Access Compliance Report

Public Rights-of-Way

Intersection ID: 5704	Main Street: W_W_T_HARRIS_BV	Cross Street: N_TRYON_ST	Location:	N
ADA ID: BBF9670F5763	Ramp Type: Directional1	Initial Pass/Fail: Fail	Overall Compliance: No	Severity Score: 12.5

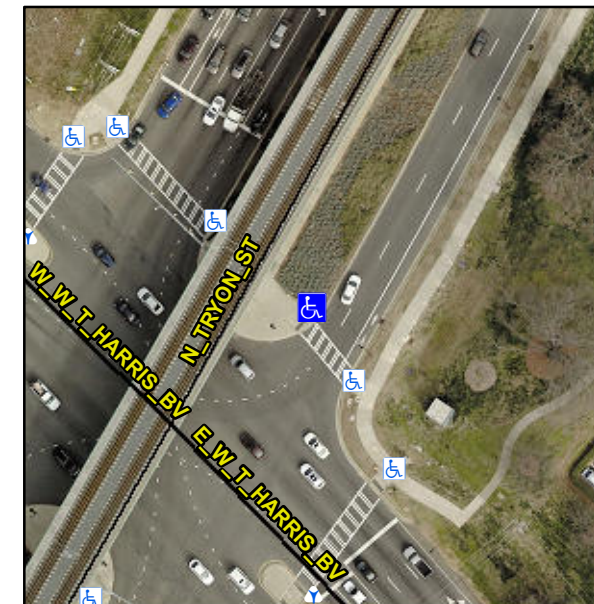
LOCATED ON MEDIAN

R304.2.2

Compliance	Description	Data	Compliance	Description	Data
N/A	Ramp Length (in)	108.0	N/A	Grade Break?	N/A
Yes	Ramp Width (in)	120.0	N/A	Grade Break Slope (%)	0.0
No	Ramp Slope (%)	11.5	N/A	Grade Break XSlope (%)	0.0
Yes	Ramp XSlope (%)	0.2			
N/A	Flare Type LT	N/A	N/A	Flare Type RT	N/A
N/A	Flare Slope LT (%)	N/A	N/A	Flare Slope RT (%)	0.0
N/A	Flare Traversable LT?	N/A	N/A	Flare Traversable RT?	N/A
N/A	Landing Length (in)	0.0	N/A	DWS Provided?	N/A
N/A	Landing Width (in)	0.0	N/A	DWS Contrast?	N/A
N/A	Landing Slope (%)	0.0	N/A	DWS Length (in)	N/A
N/A	Landing X Slope (%)	0.0	N/A	DWS Full Width?	N/A
N/A	Landing Curb? (Y/N)	N/A	N/A	DWS Offset LT (in)	N/A
N/A	Shared Landing?	N/A	N/A	DWS Offset RT (in)	N/A
N/A	Gutter Ponding?	0.0	N/A	Gutter Slope (%)	N/A
N/A	Gutter Lip Ht (in)	1.0	N/A	Gutter X Slope (%)	N/A
N/A	Painted X Walk1?	No		Road Slope (%)	0.0
	X Walk 1 Direction	To SE		Road X Slope (%)	0.9
	X Walk 1 Width (in)	N/A		Clear Space?	N/A

Remove & Replace Entire Ramp.
